SUBJECT: Responds to concerns re spurious operation of high-low pressure interface valves due to fire, per 850327 meeting & 840808 SER re alternate safe shutdown capability. Replacement pages for util 840206 submittal encl, for inclusion in SER.

H. B. ROBINSON STEAM ELECTRIC PLANT, UNIT NO. 2
DOCKET NO. 50-261/LICENSE NO. DPR-23
APPENDIX R - ALTERNATE SHUTDOWN CAPABILITY
OPEN ITEM RESOLUTION AND ADDITIONAL CLARIFICATION

ATTACHMENT 3
REPLACEMENT PAGES TO
FEBRUARY 6, 1984 SUBMITTAL

Figure 2-1. Post-Fire Operator Actions Required to Achieve Safe Hot Shutdown

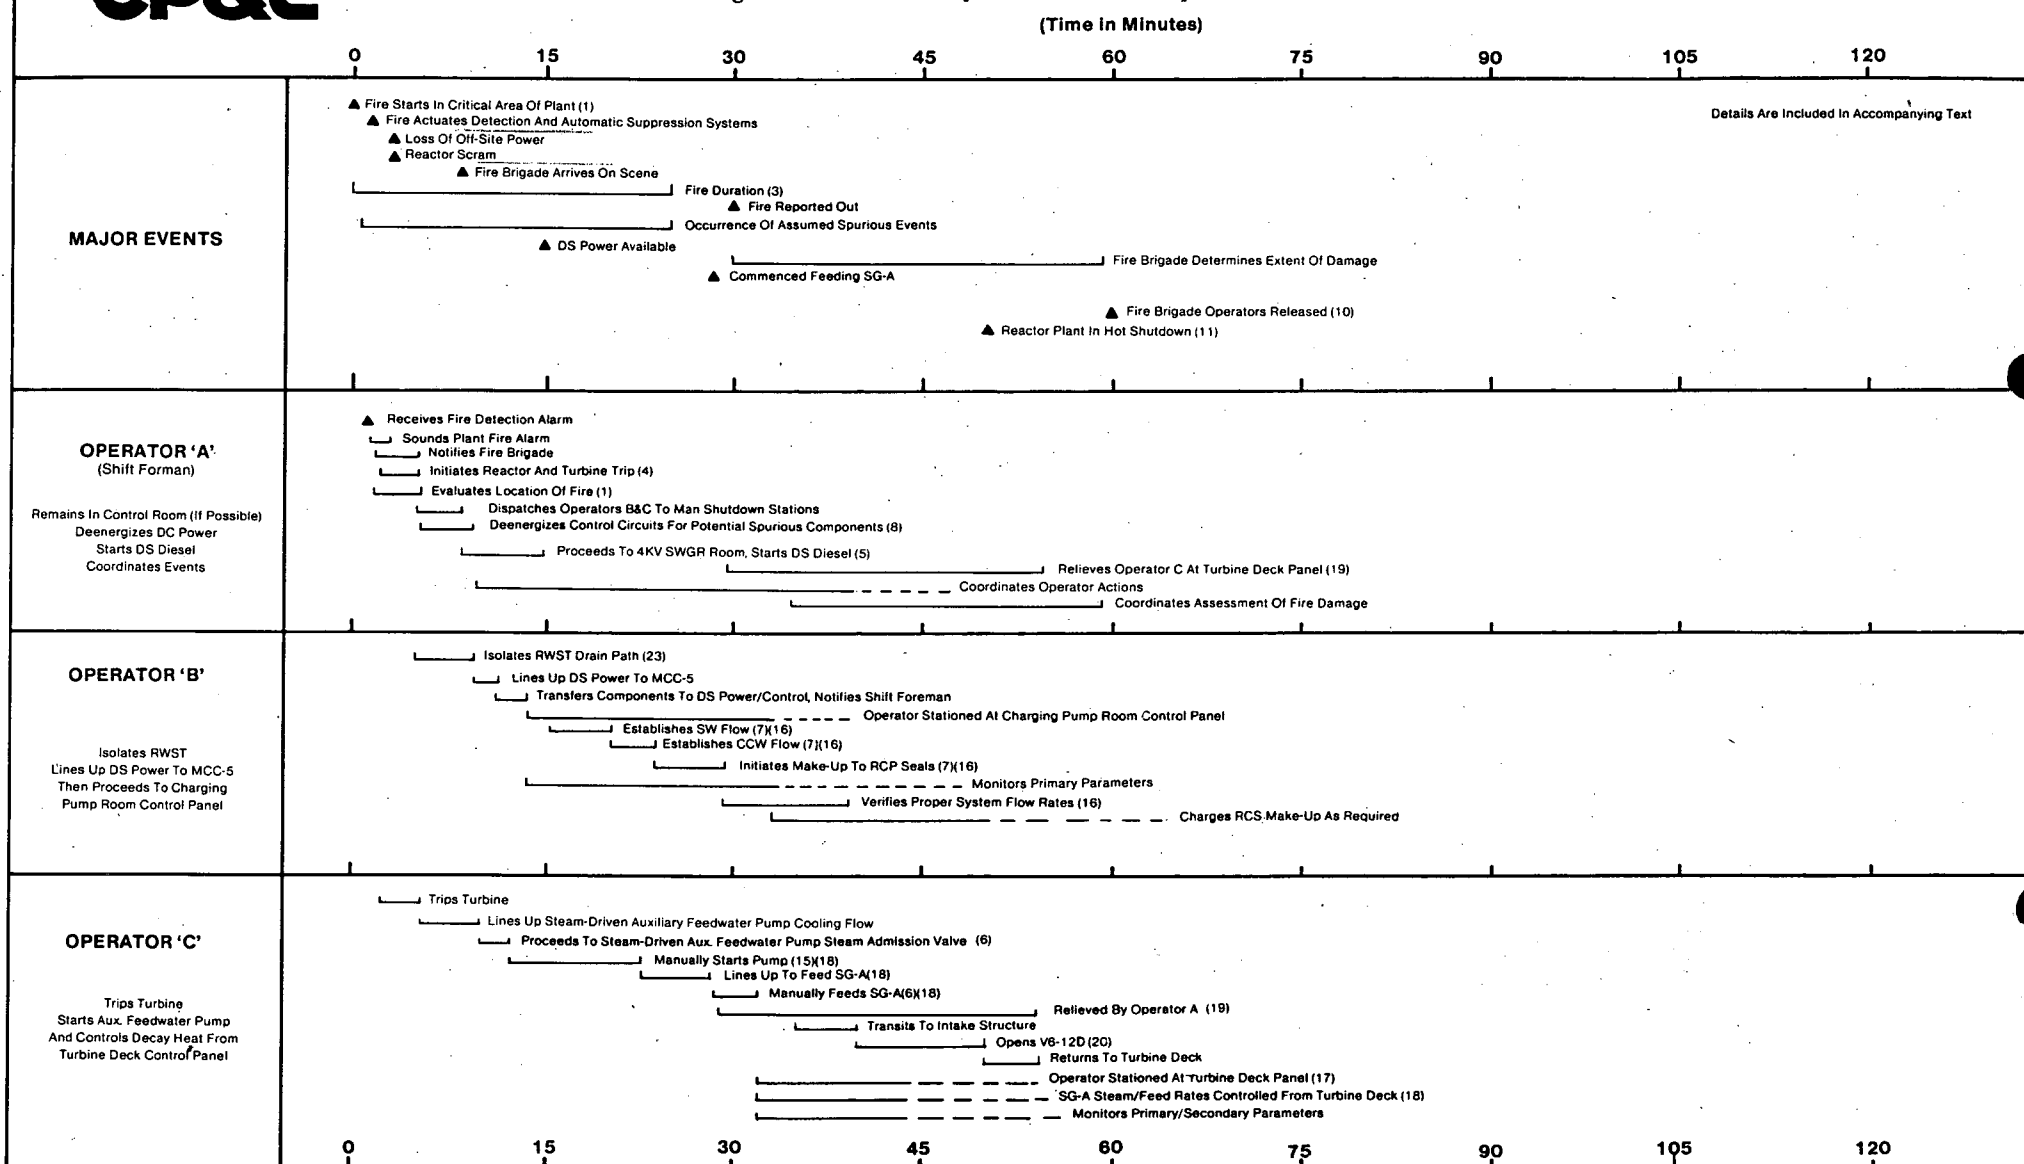
The foregoing safe shutdown scenario was used to develop the post-fire timelines. One of the very first actions to be taken is to initiate feed water supply to the steam generators in sufficient time to avoid steam generator dryout. The immediate post-fire actions are detailed in Figure 2-1. This figure covers the critical period from the start of the fire to the achievement of a hot standby condition. Figure 2-2 illustrates the overall sequence of required operator actions leading to successful achievement of cold shutdown. The number of operators required is also provided. The details supporting the development of the timeline construction are listed in the corresponding "Figure Notes" shown on pages 2-18 through 2-20.
